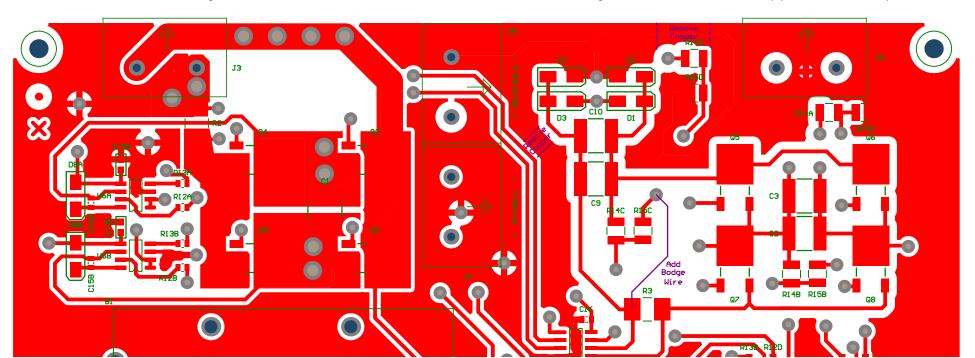
Note: All removed copper needs to be 1.5 mm wide or wider.

In addition the bodge wire must remain a minimum of 1.5mm away from all other copper and components.

Note: All removed copper needs to be 1.5 mm wide or wider.
